**UN Regulation No. 134 (Hydrogen and Fuel Cell Vehicles)**

**Proposal for Supplement 2 to the 02 Series of Amendments to  
UN Regulation No. 134 (Hydrogen and Fuel Cell Vehicles)****Submitted by the Task Force amending UN Regulation No. 134 \***

"Figure 2

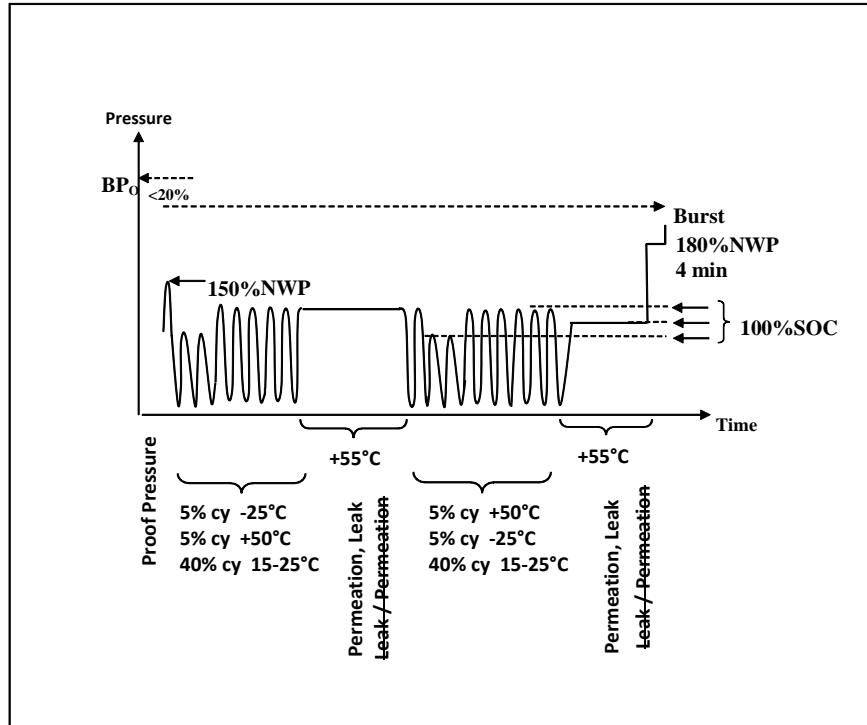
Figure 2., amend to read:

### Verification Test for Expected On-Road Performance (Pneumatic/~~hydraulic~~)

This proposal clarifies the order of the permeation and leakage tests in Figure 2 so as to be in line with the text, and also streamlines the wording for headings and text relating to these tests.
